Staff Report

Re: PLNSUB2017-00324 Planned Development
PLNSUB2017-00504 Preliminary Subdivision

Planned Development and Preliminary Subdivision

PROPERTY ADDRESS: approximately 842 and 834 Hoyt Place
PARCEL ID: 08-35-405-017, 08-35-405-018
MASTER PLAN: North Temple Boulevard Plan/800 West Station Area Plan
ZONING DISTRICT: SR-3, Special Development Pattern Residential District

HOYT PLACE TYPICAL SECTION

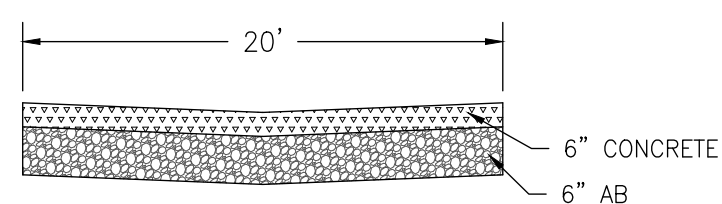
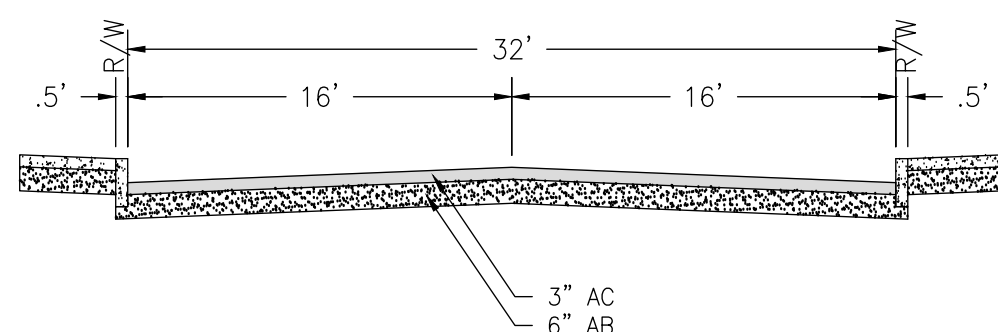
Since Hoyt Place is a private street, Transportation Division has little oversight. The fire marshal should verify whether they will allow parking on both sides as it will leave only 18 feet clear space with 32' curb to curb. Since it is private I don't think the on-street parking credit would apply. Allowing parking between the units overlapping property lines seems to be an issue that will cause future problems between residents on who gets to park there. The 30 feet between facades for the drive aisle will be tight but is adequate for vehicles to maneuver getting in and out of the garages. Typically we

After reviewing this and speaking with you I believe that this project came up in a telephone conversation with Ted and I based on road widths. The developer/architect will need to show the road widths from curb face to curb face and indicate where parking will be prior to any approval. They will also need to show the radius of the turnaround to ensure that it meets code. Right now this cannot be approved until they show dimensions and submit an alternative means and methods for the alternative to a hammerhead. Because of the issues we have seen with the alternatives to the three primary turnarounds we will need to extend the turn from 70' to 80', this will include the space past the backing lane.

- The measurement for parking is a minimum of 6 ft. width.
- When a fire department access road measures 32 ft. measured from the face of high-back curb to the face of the high-back curb, will accommodate parallel parking on both sides of the street with fire department access.

SHEET No. **C-1**

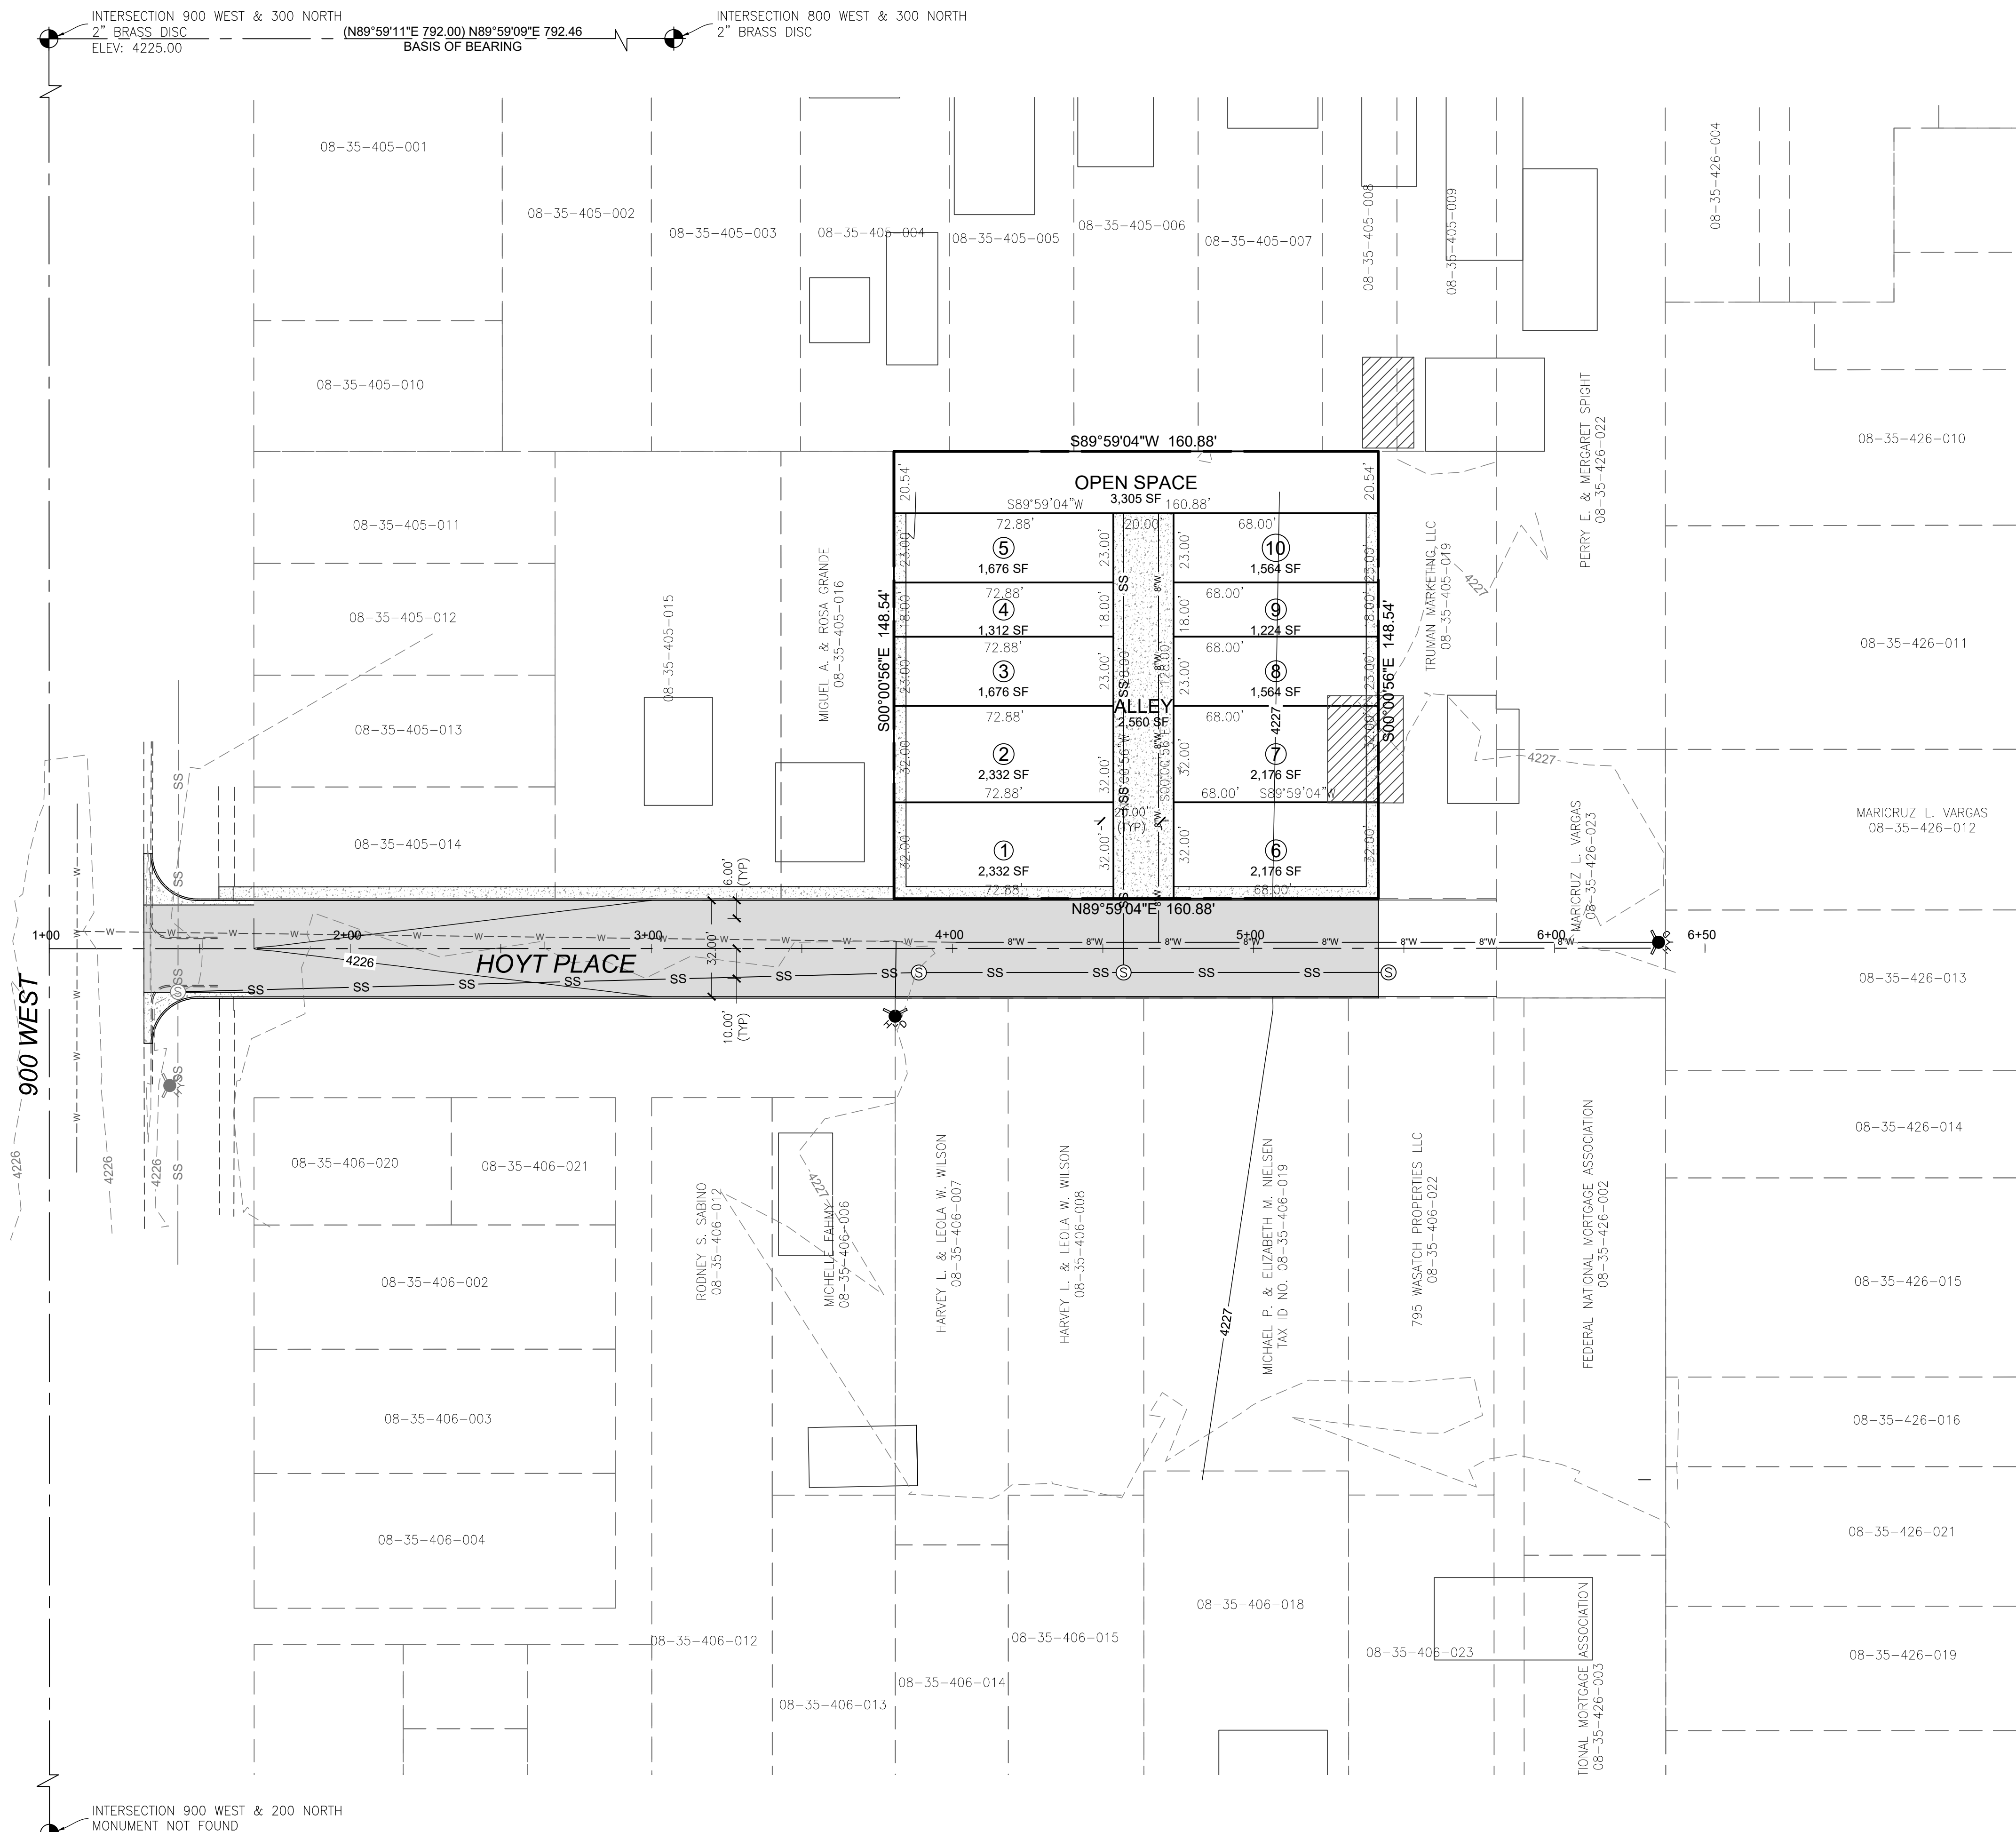
- Viewing this proposed planned development as “fronting” on Hoyt Place; this proposal does not seem to comply (the east dwellings are setback only 11’-3” from the east property line).

- Viewing this proposed planned development as “fronting” on Hoyt Place; this proposal does not seem to comply because all front doors face the abutting properties to the east and the west and not on a street.

- The minimum inside width of each two car garage for the single-family attached dwelling units is insufficient for two cars as determined by 21A.44.020 E.2.a (18’-6” minimum as measured from inside of outer wall to inside of outer wall). Each garage would be considered a one-car garage with storage unless modified accordingly.

- Lots 4 & 9 are less than the twenty two foot (22’) minimum lot width requirement and the one thousand – five hundred square foot (1,500 sq. ft.) requirement of 21A. 21A.24.100 C.

- Building height shall be measured as the vertical distance between the top of the roof and the established grade at any given point of building coverage. Existing & proposed grade contour lines shall be shown at a minimum of two foot (2') intervals on a site plan or grading plan for review of building height and interior side yard wall height.
- The side yard setback dimensions of Lots 5 & 10 have not been identified.
- If the garage side of each lot is the rear yard as shown on the elevation drawings; none of the lots meet the rear yard setback requirement of 21A. 21A.24.100.
